PLANNING COMMISSION MEETING

RE: Culver's- Preliminary Site Plan Review – 2nd Review

RE: Culver's
Preliminary Site Plan – Review #2

1 EAST (RIGHT SIDE) ELEVATION

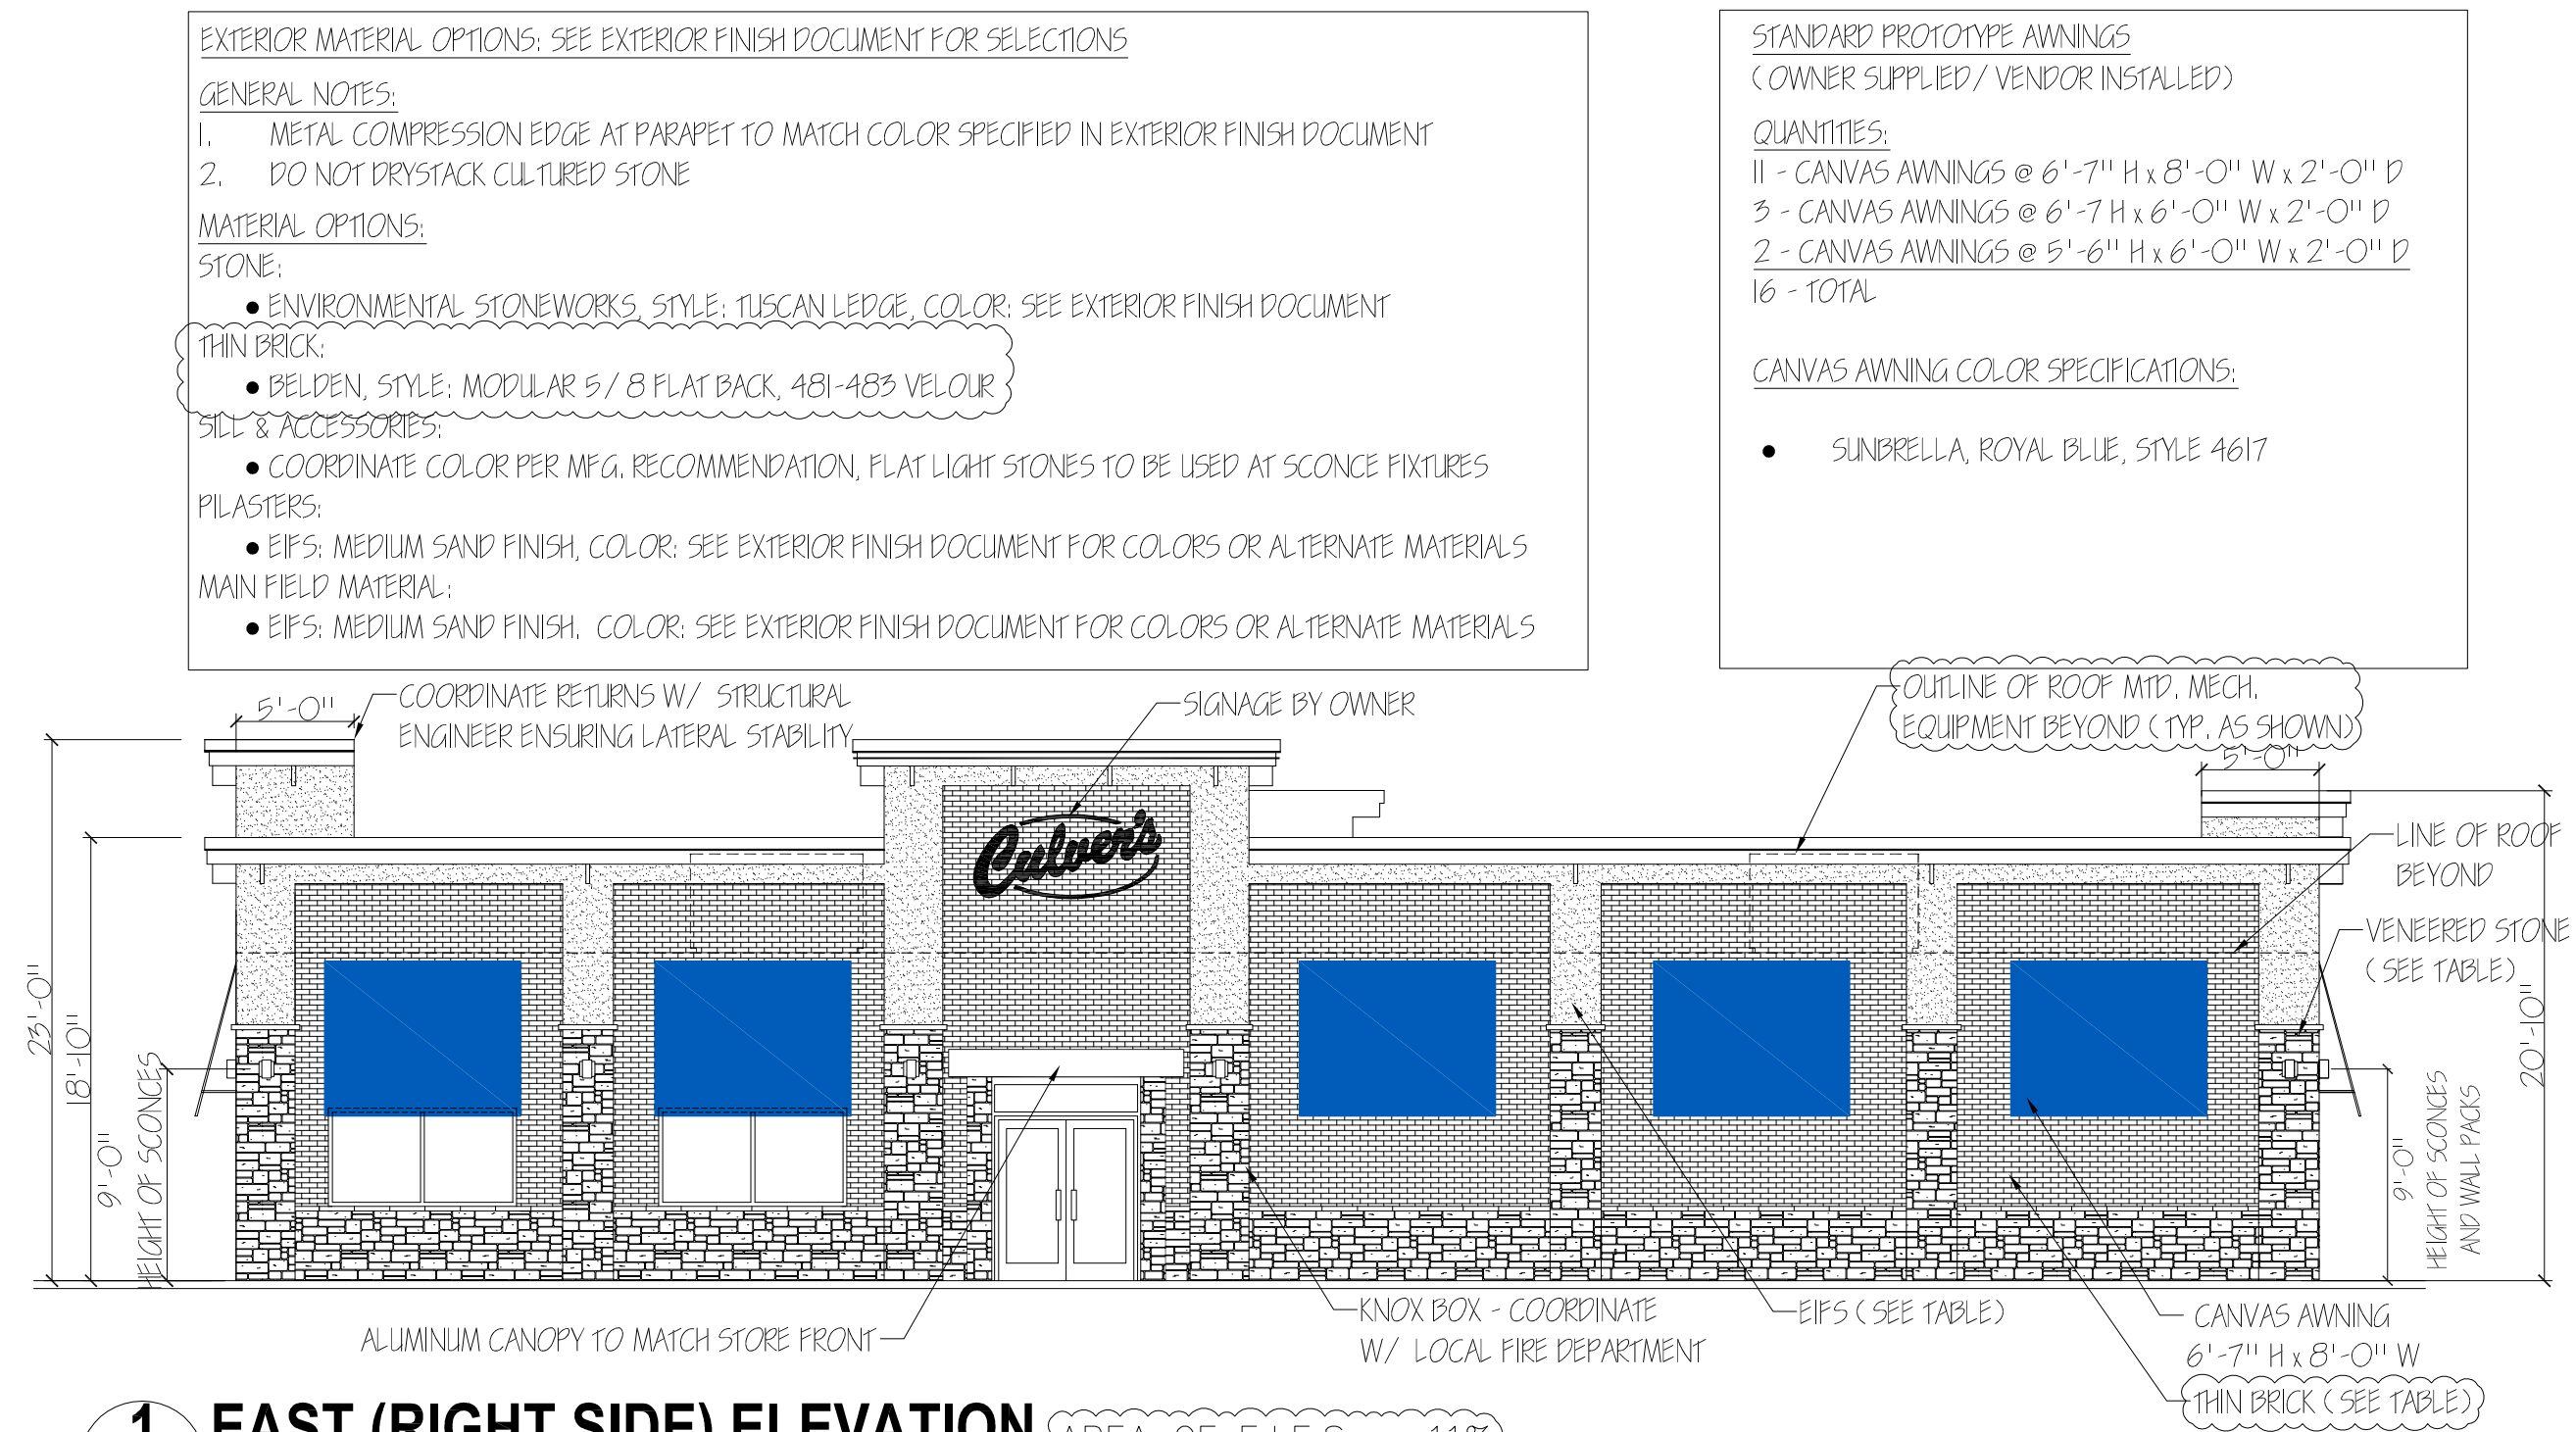
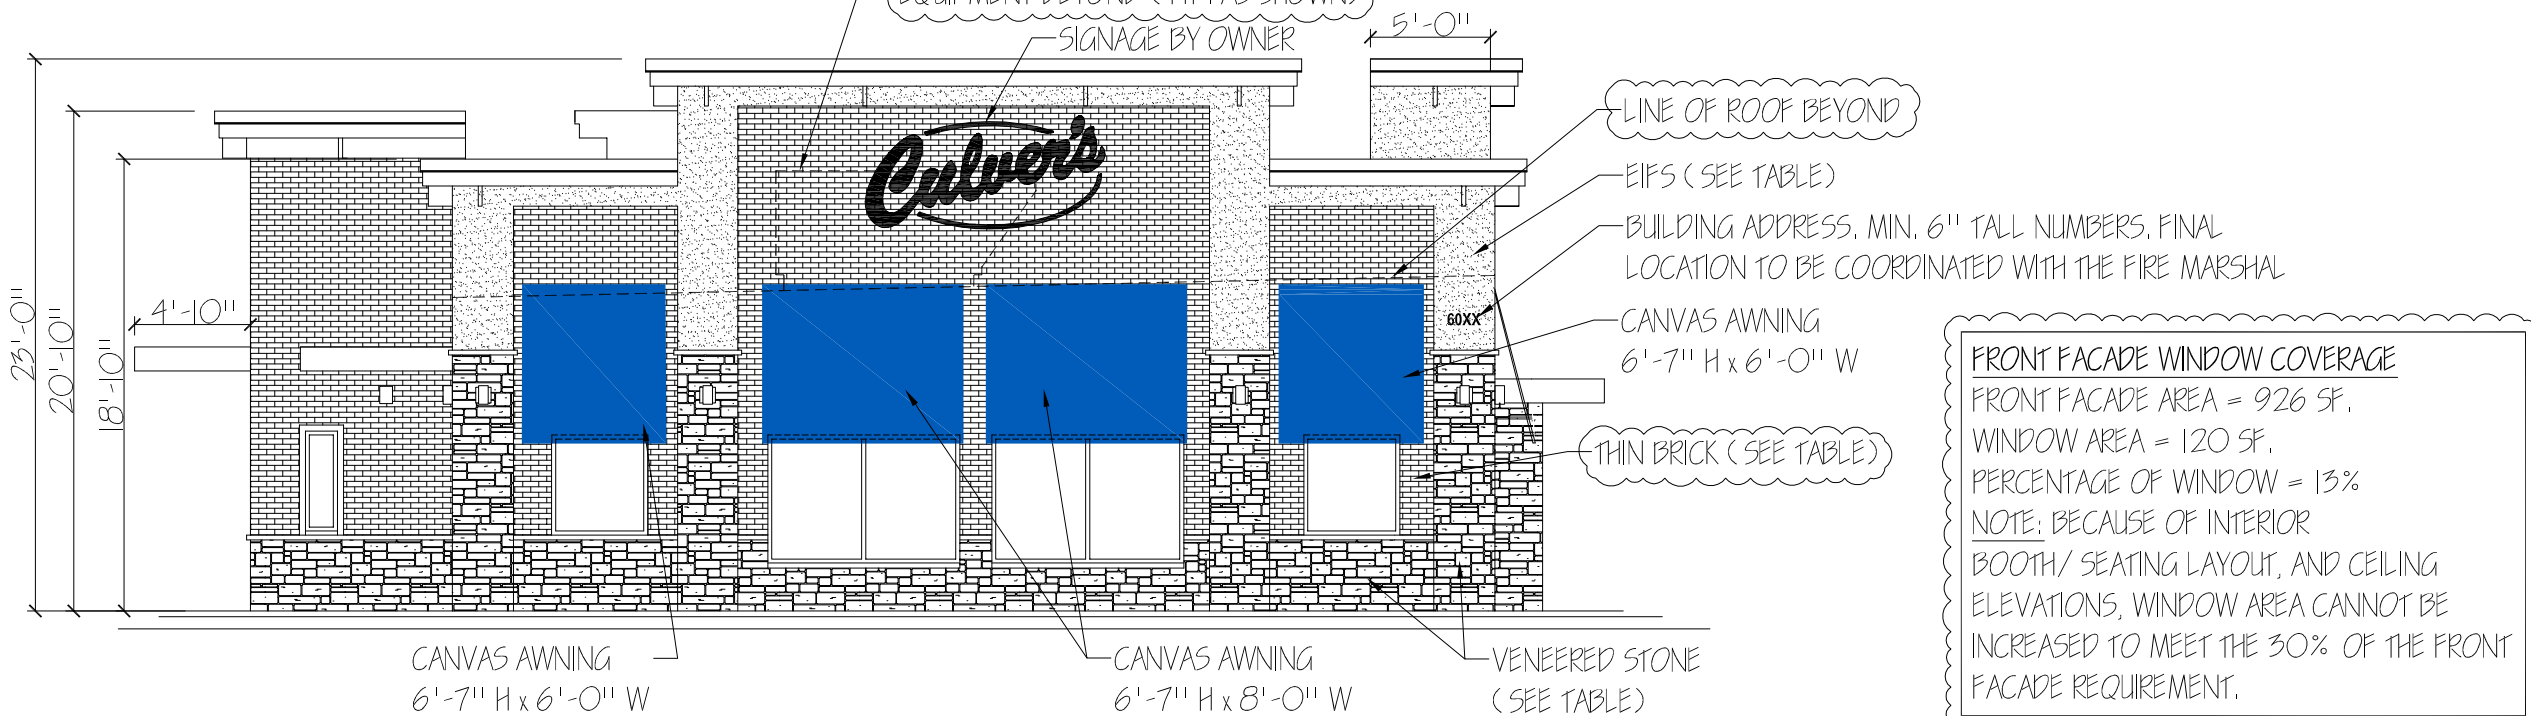
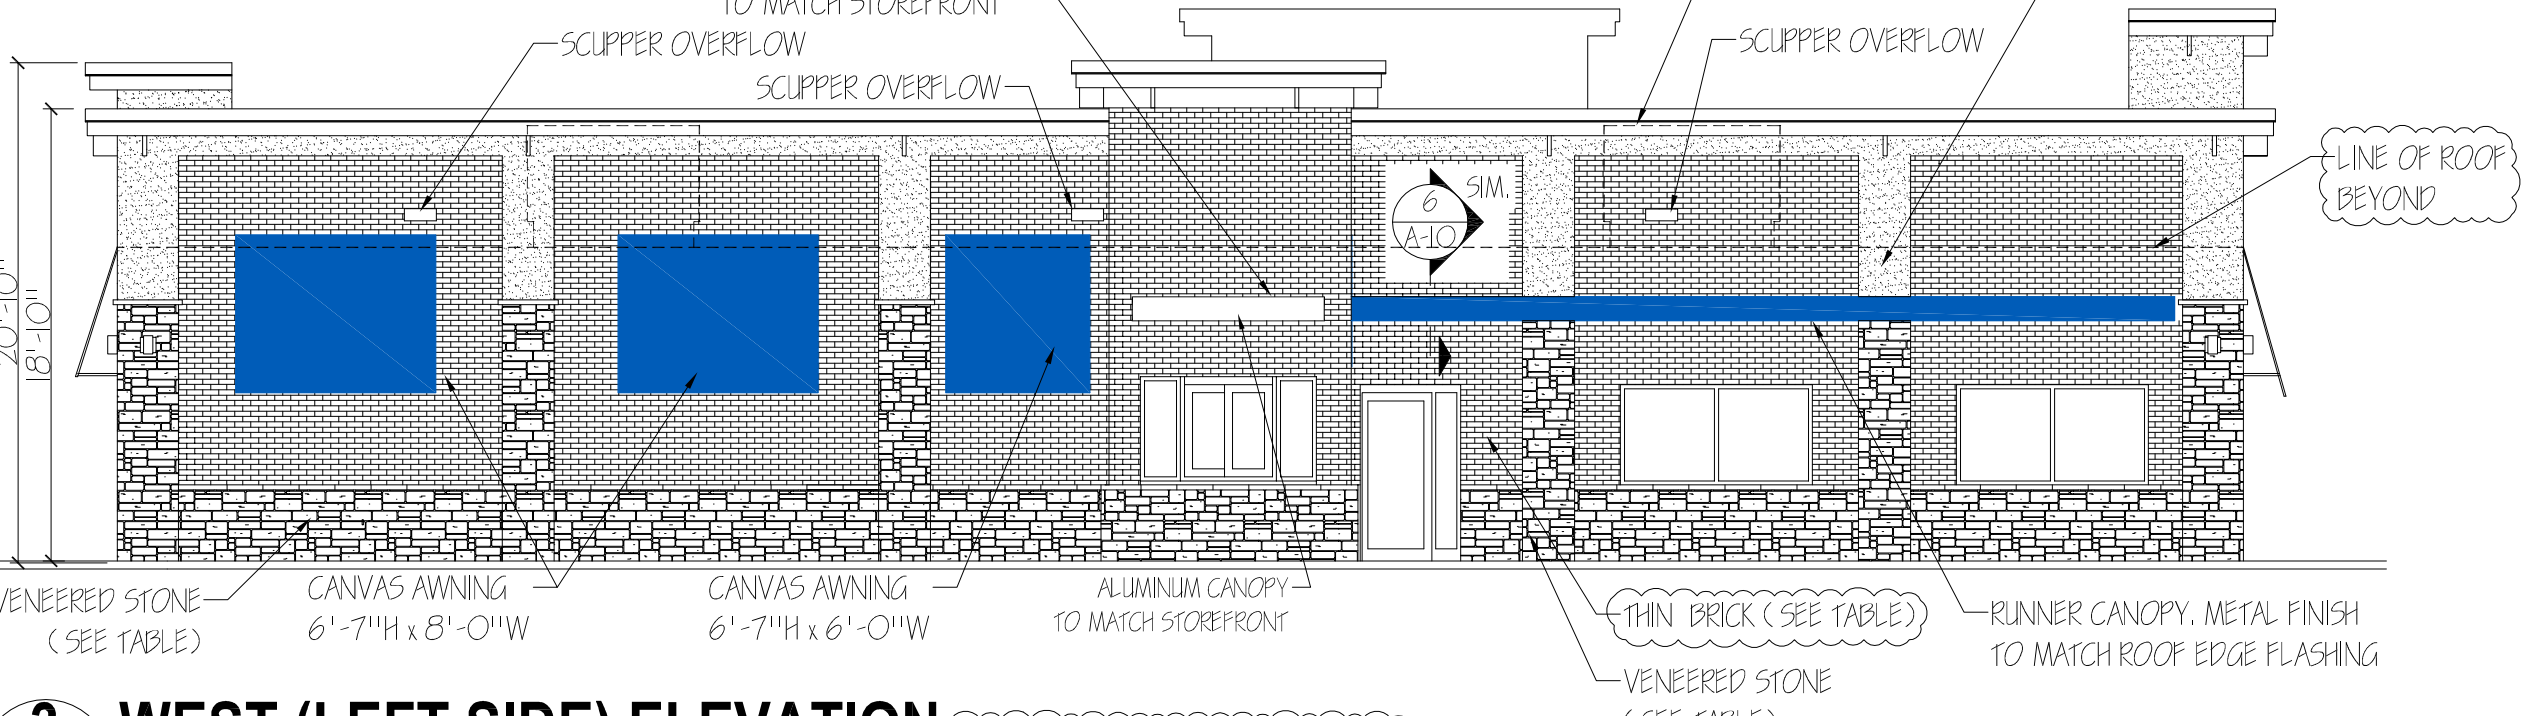
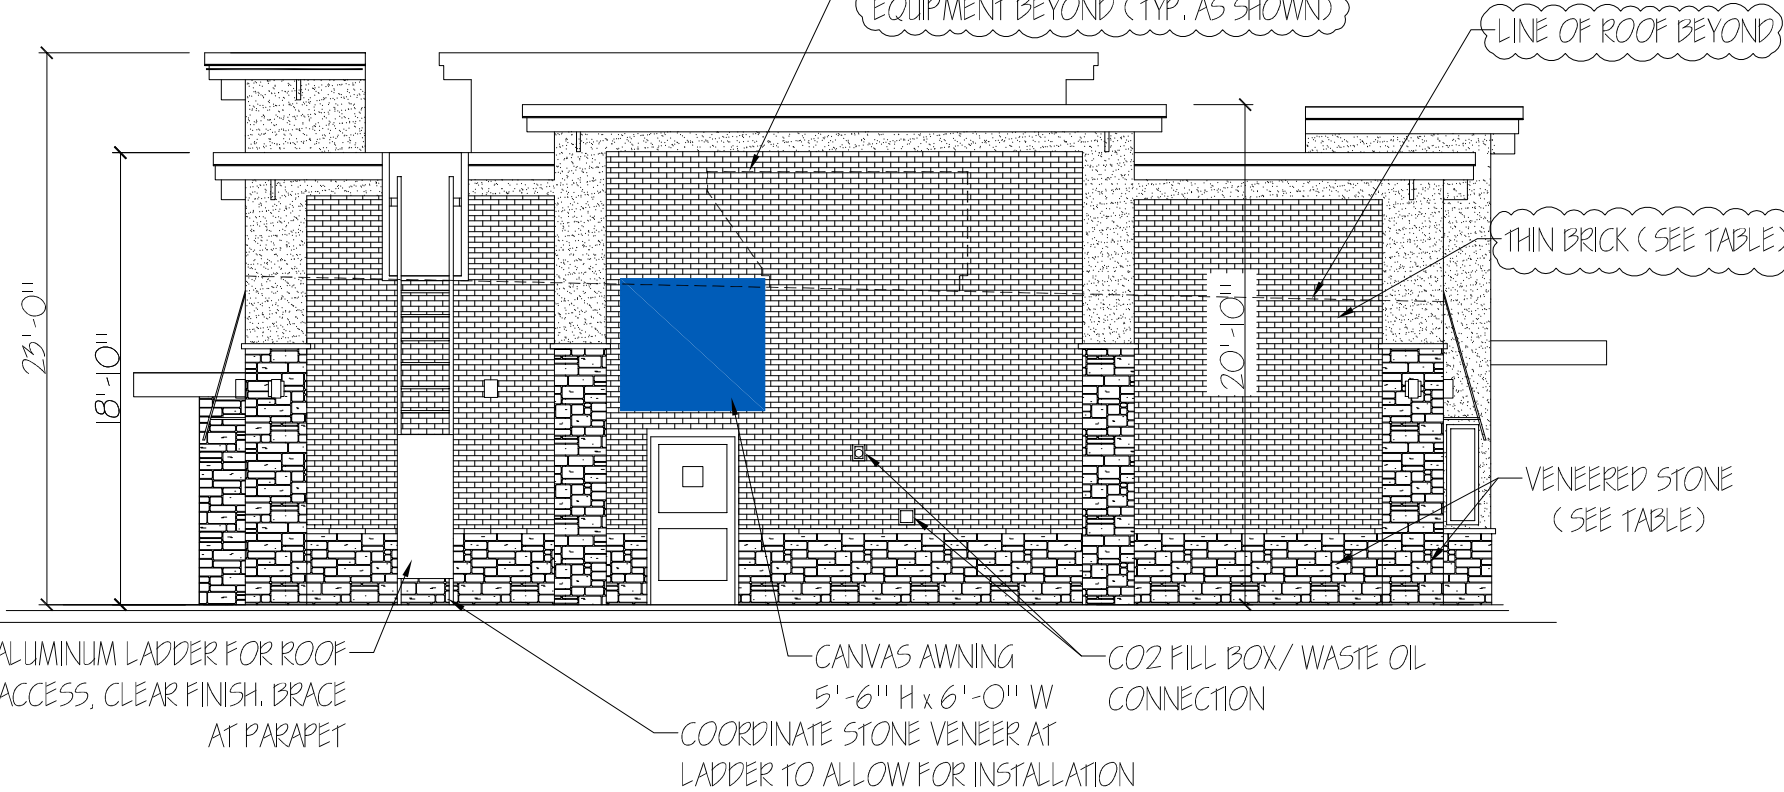
Exterior building materials should be comprised primarily of high quality, durable, low maintenance material, such as masonry, stone, brick, glass, or equivalent materials. Buildings should be completed on all sides with acceptable materials **(consideration shall be given to all four facade designs as each side of the building would be visible from a street).** (See response to following comment in this paragraph). The proposed materials for the 18-foot-tall building (23-foot-tall parapets) are a mix of EFIS (exterior insulation finishing system) and stone veneer, with canvas awnings. **A majority of the building material is EFIS, with stone veneer as an accent around the base of the building. EFIS is not considered a high-quality building material. Staff recommends 70 percent of all elevations of the building be covered with some type of brick or stone veneer product.** (Comment addressed. In the response letter provided to the first review, the Applicant's engineer stated all building faces have a minimum of 70% brick and/or stone veneer product. Percentage of EFIS has been provided for each of the building elevations).

The Zoning Ordinance states all buildings should have windows at eye level covering at least 30 percent of the front facade. The exterior elevations should be revised to provide the required windows, and a window coverage calculation shall be provided on the building elevations at final site plan. (Comment outstanding. A waiver is required because 30% window coverage on front facades is not provided. The east and north elevations are also considered front facades (due to fronting on roads) and shall be labeled as such on Sheet A-3, with window coverage calculations provided for those facades. Also, revise requested waiver seven on Sheet C000 to reflect the three affected facades).

The exterior elevations of all four sides of the building indicate the cornice contains optional blue LED accent lighting. Trim accent lighting at or above the roofline is prohibited signage and a waiver would be required to install such lighting. Staff suggests Sheet A-3 be revised to remove the optional blue LED accent lighting. (Comment addressed. The blue LED accent lighting has been removed from the building elevations).
